APPLE1 / WOODEN ENCLOSURE

Corrected side profile / keyboard slope ends at the flat shelf

APPLE1 / WOODEN ENCLOSURE

Corrected form: keyboard deck rises, then meets a flat monitor shelf at equal height

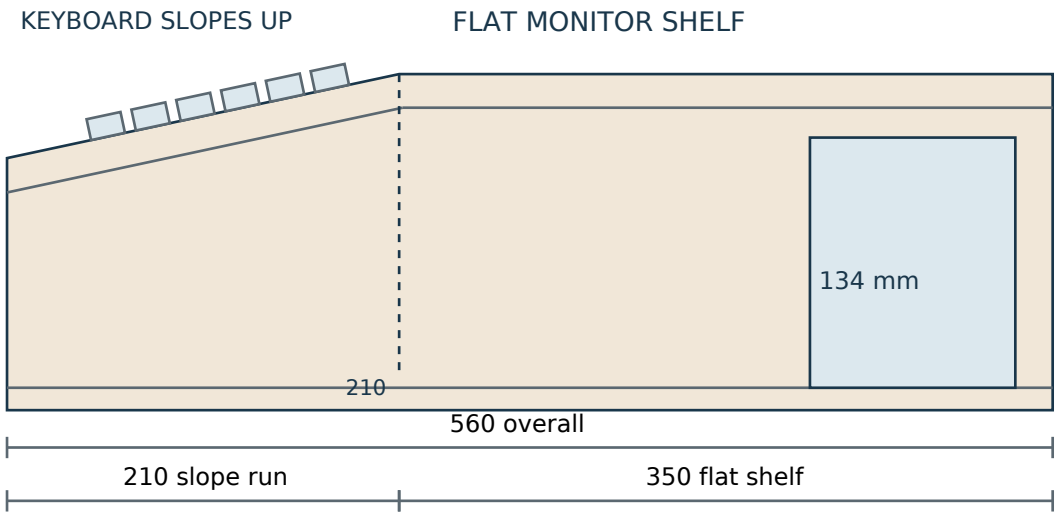
Front 135 mm / shelf 180 mm. Slope ends at depth 210 mm, level with the shelf.

Keep the entire upright CFFA1 + CF envelope under the shelf. The marked depth 430-540 mm zone has 150 mm interior height; the conservative 134 mm allocation leaves 16 mm. Clearance is uniform beneath the shelf.

Keep Replica 1 Plus horizontal on mounts with a total 10 mm rise. Orient/place it so the slot and complete card envelope occupy the marked zone. The zone is a placement constraint; motherboard outline and mounting holes still need fitting.

424 mm inside width: 230 mm motherboard/card zone, 20 mm gap, 160 mm NEURAL1 zone and 14 mm spare. These planning zones require assembly fitting.

Transfer the actual keyboard aperture, brackets and keycap clearance. Support it parallel to the slope. Optional side trim rises 8 mm above the deck. Keep rails out of the CFFA zone.

R04 replaces R03: the keyboard deck rises to a level rear shelf. Its end height equals the shelf height. The transition changes angle only; it has no vertical step.

PLAN VIEW

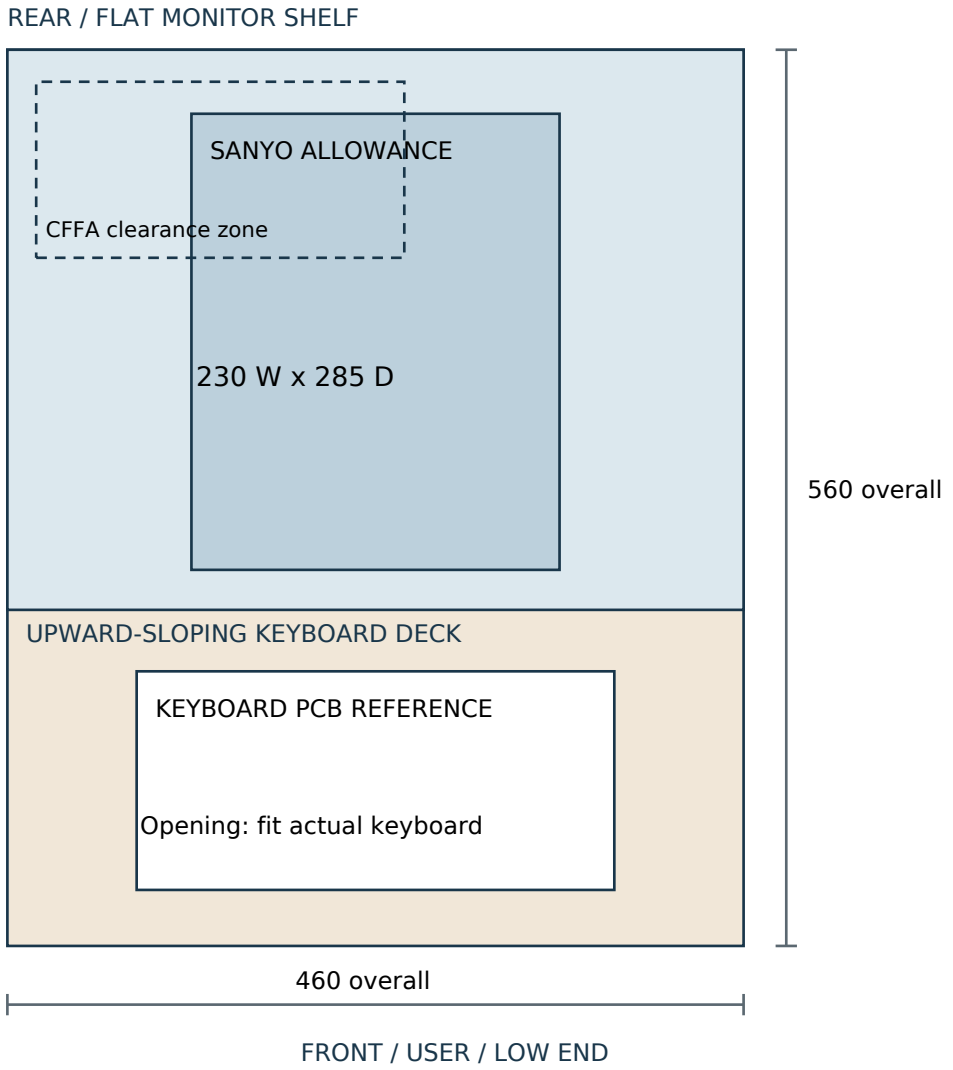
460 W x 560 D mm footprint. Front deck rises from 135 mm to 180 mm over 210 mm horizontal depth (12.09 degrees). It meets a flat 350 mm-deep rear shelf at 180 mm. Heights exclude feet and raised side trim.

Mount the keyboard parallel to the rising front deck. At depth 210 mm the deck ends at the shelf surface height. The top changes from inclined to horizontal there, with a flush joint and no vertical riser.

Sanyo rests directly on the flat rear shelf. Use its normal feet and preserve ventilation clearance. No leveling cradle is required. Keep the monitor footprint within depth 235-520 mm.

18 mm side walls and flat monitor shelf; 18 mm sloping keyboard deck measured normal to its surface; 12 mm removable bottom. Use screws and threaded inserts for removable shelf access to the CF card.

The card envelope is positioned entirely beneath the horizontal rear shelf, so the keyboard slope does not reduce its headroom. Keep it clear of the transition joint, shelf supports and fasteners. Any baseplate or mounting rise above the allocated 10 mm reduces the 16 mm gap millimetre for millimetre.
